Your Ref: DA-2020/4 **Our Ref:** P18-225

RE: RESPONSE TO COUNCIL'S RFI FOR DA 2020/4 - 14 COSGROVE AVENUE, KEIRAVILLE

This letter has been prepared on behalf of our client, Surewin Parkview Pty Ltd (the applicant), and provides further clarification and information to address various matters raised in Council's letter. This response is supported by:

Figure 1: WLEP Zoning Map Extract. Subject site shown with a red star. E3 and E4 zones circled red. Other R2 zones adjacent to the E2 zone circled blue.

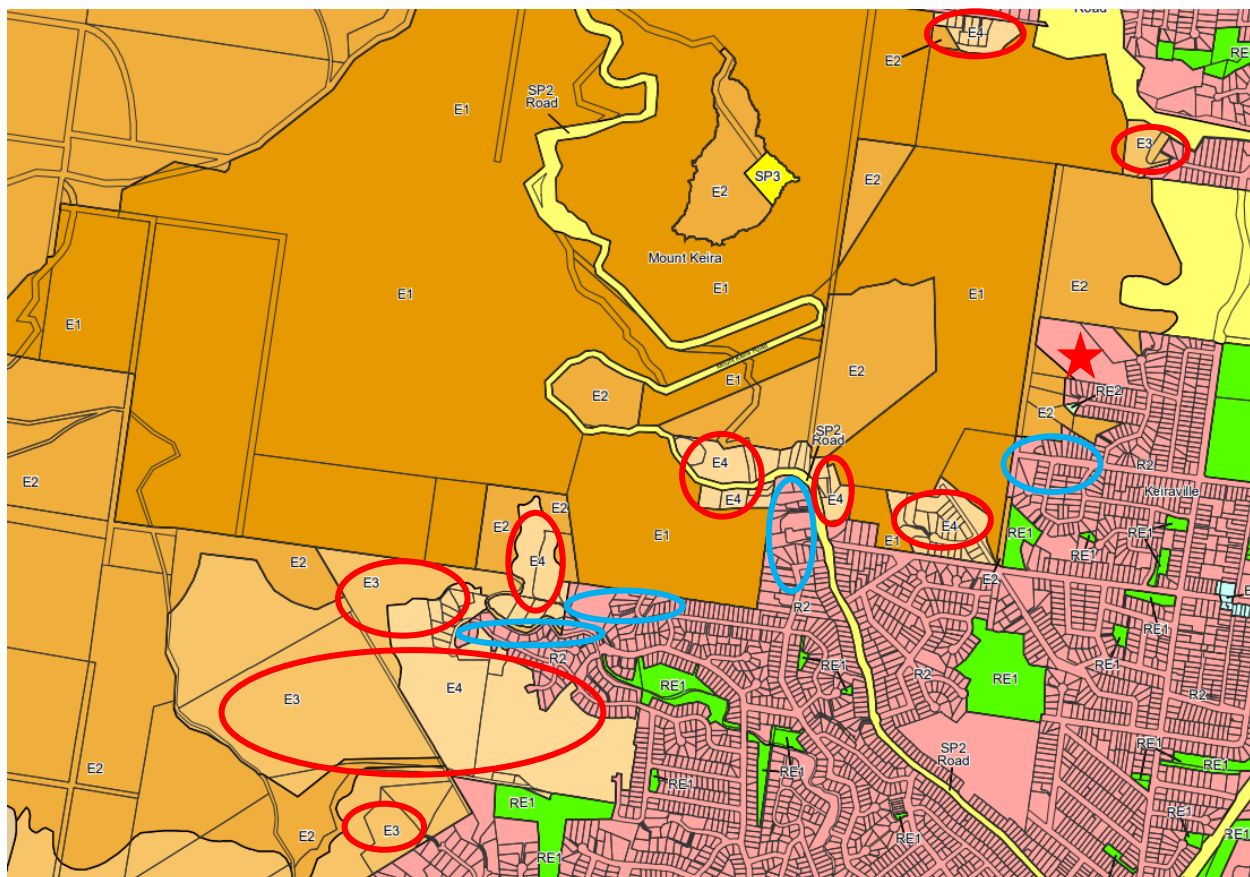
The subject site is zoned R2 Low Density Residential and is subject to the same planning controls as the neighbouring residential sites. The R2 zone permits with consent, multi dwelling house, residential flat buildings, shop top housing and a range of non-residential uses.

Where there is an expectation to provide a lower scale of development adjacent to the Illawarra Escarpment, these sites have been zoned either E3 Environmental Management or E4 Environmental (see Figure 1). These E3 and E4 zones permit dwelling houses and semi-rural type activities and would provide a decreasing gradient of density adjacent to the E2 zone. Council in its zoning of the site R2 (as opposed to E3 or E4) recognised that it was suitable for development at a scale that is permitted in the R2 zone.

**ATTACHMENT 2 - VIEWS TOWARDS SITE FROM WITHIN THE ILLAWARRA ESCARPMENT (GB
HERITAGE)**

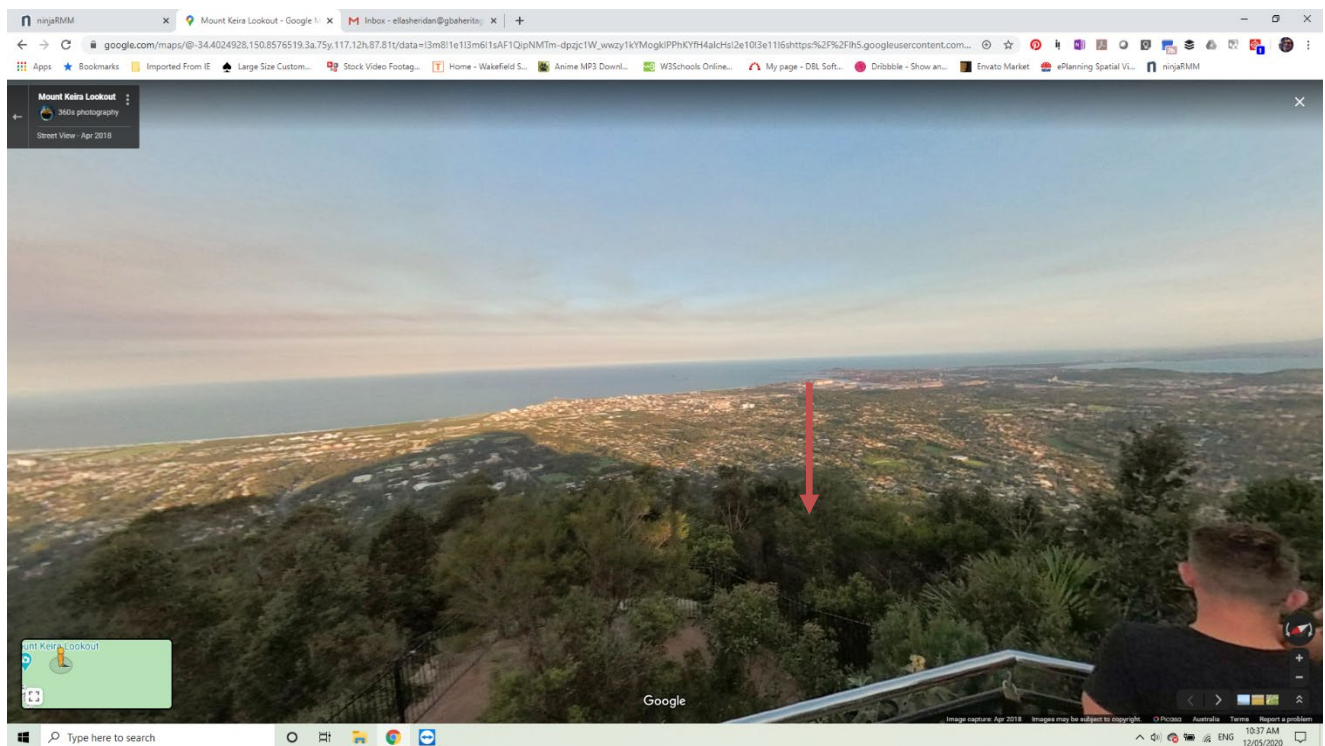
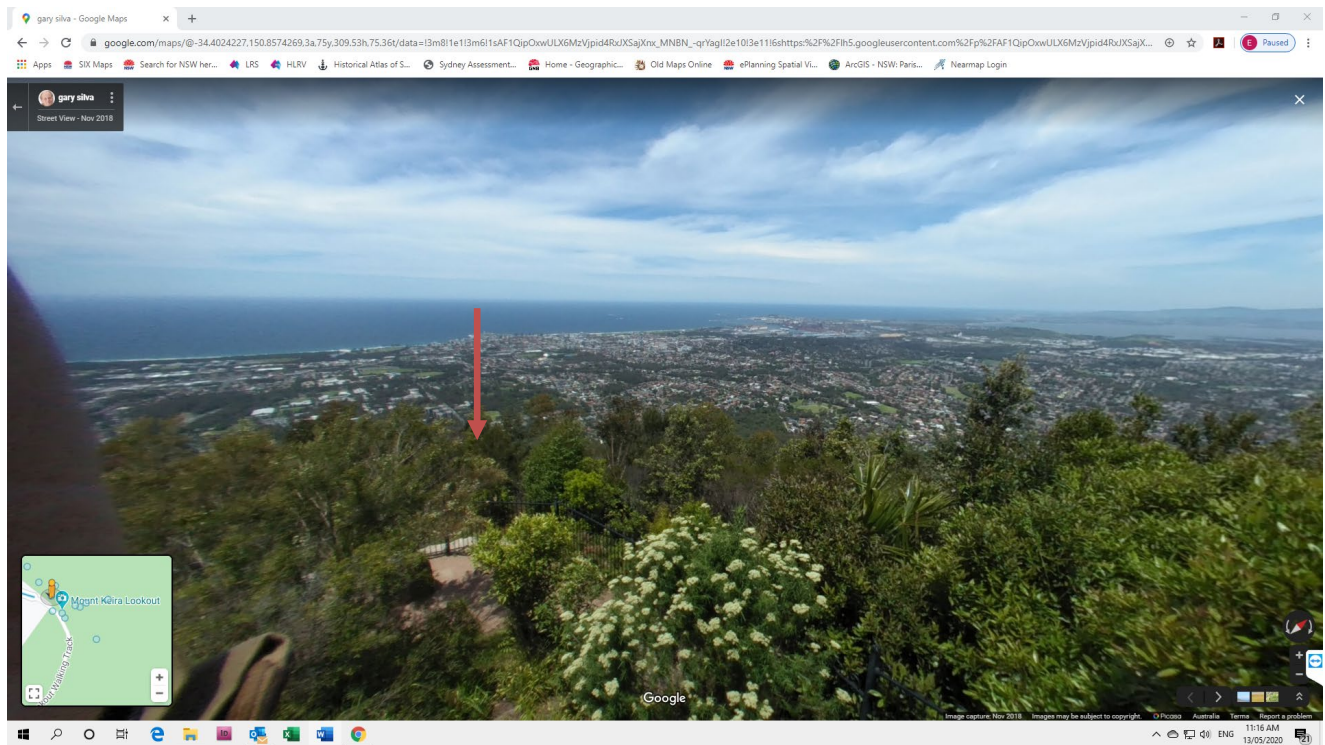
Views from Mount Keira Lookout to the east. The subject site is not clearly visible or discernible. The red arrows indicate the approximate location of the subject site.
